DESCRIPTIVE REPORT

Registry Number: **H11920**

Sub-locality: Gay Head to Cedar Tree Neck

**Project OPR-B307-TJ-08
 Gay Head to Cedar Tree Neck
 Rhode Island Sound and Approaches, RI and MA
 Scale 1:10,000
 July 15th – September 08th 2008
 NOAA Ship *THOMAS JEFFERSON***

Figure 1.9.1

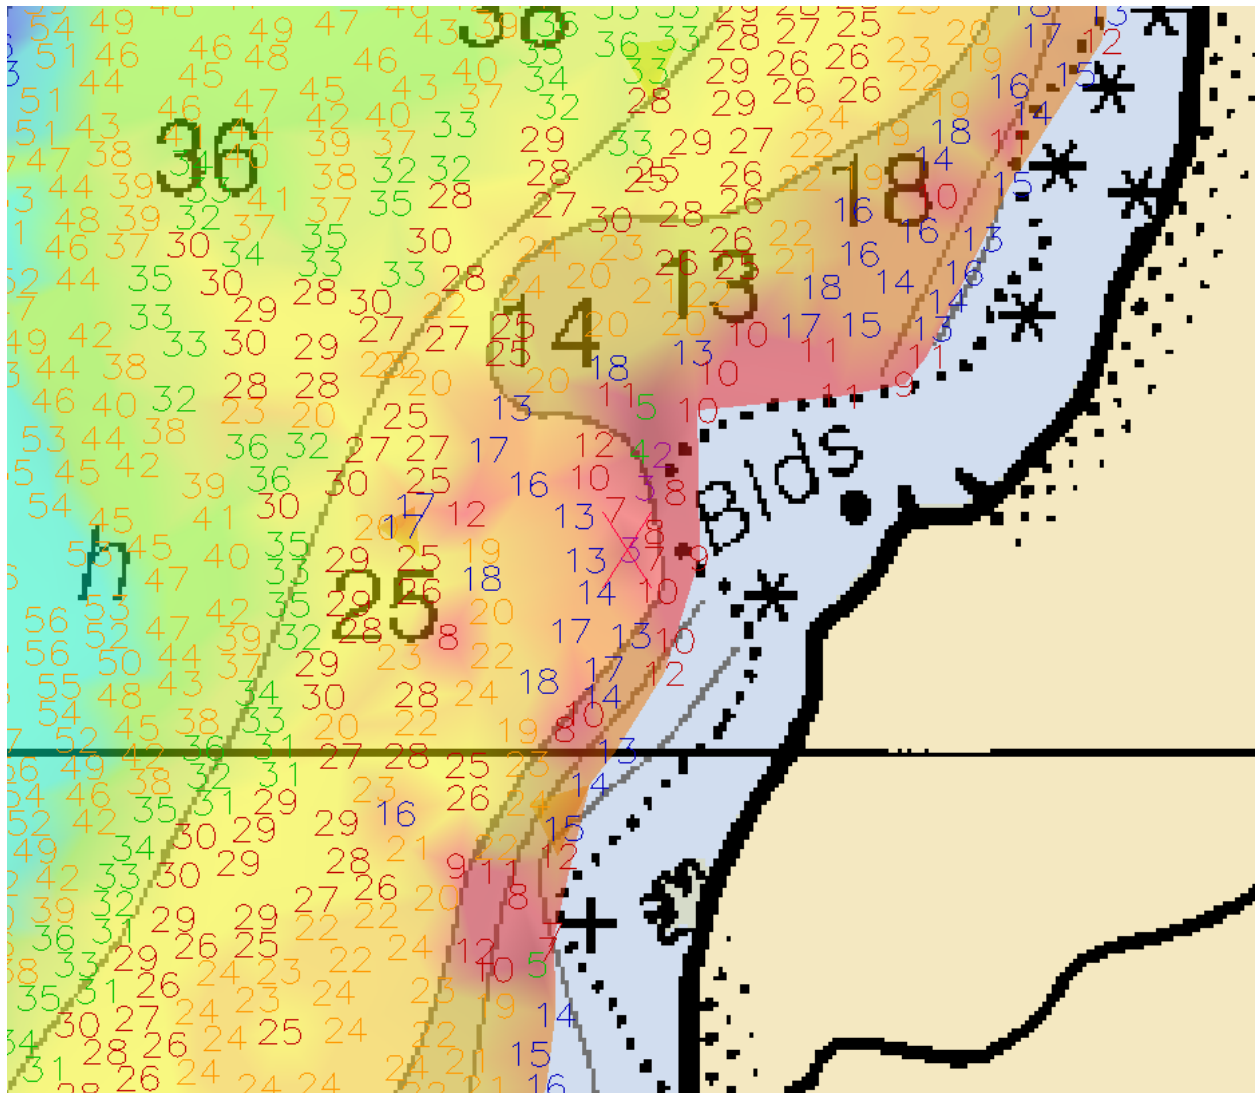
Feature is outside foul line, AHB recommends to update foul line to include this feature.

Figure 1.10.1

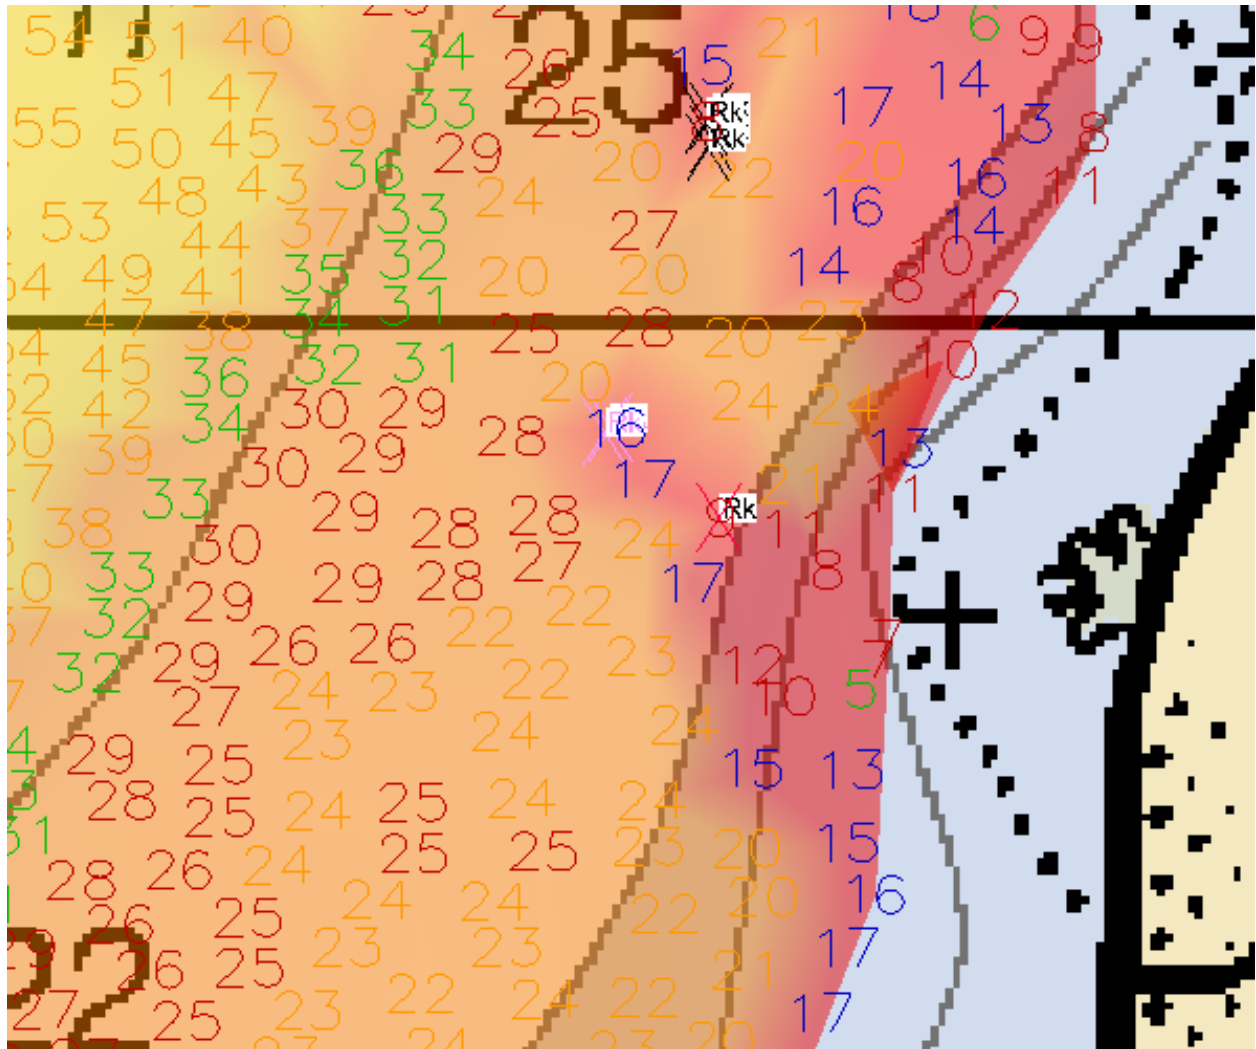
Rocky Area, AHB recommends to update foul line to include these features.

NOS Chart 13233_1

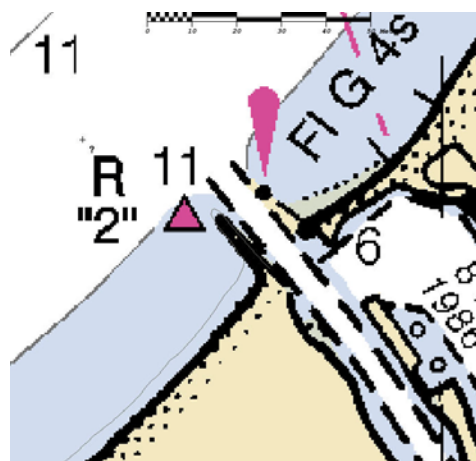
- a. The jetty along the entrance to Menemsha Pond (Latitude $41^{\circ} 21' 14.996''$ N, Longitude $070^{\circ} 46' 08.539''$ W) is incorrectly charted on NOS chart 13233_1, 18th edition. Jetty/Shoreline position according to USGS the National Map Seamless Server Viewer, MA - State (Apr 2005) was submitted as a COALNE feature with the H-Cell products to MCD. It is recommended that the jetty's position be updated on the raster. See image below.

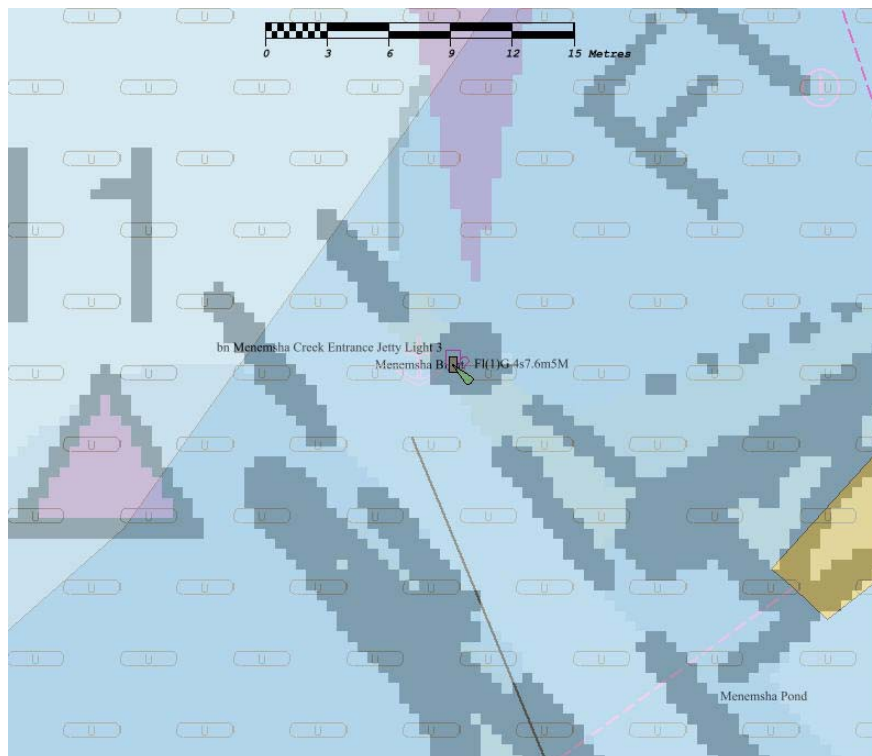
- b. The coastline along Latitude $41^{\circ} 20' 42.039''$ N, Longitude $070^{\circ} 46' 08.795''$ W to approximately Latitude $41^{\circ} 20' 36.297''$ N, Longitude $070^{\circ} 46' 17.738''$ W was incorrectly charted on NOS chart 13233_2, 18th edition. The coastline was re-digitized using USGS the National Map Seamless Server Viewer, MA - State (Apr 2005). It is recommended that the coastline be updated to agree with the orthophotograph. See image below.
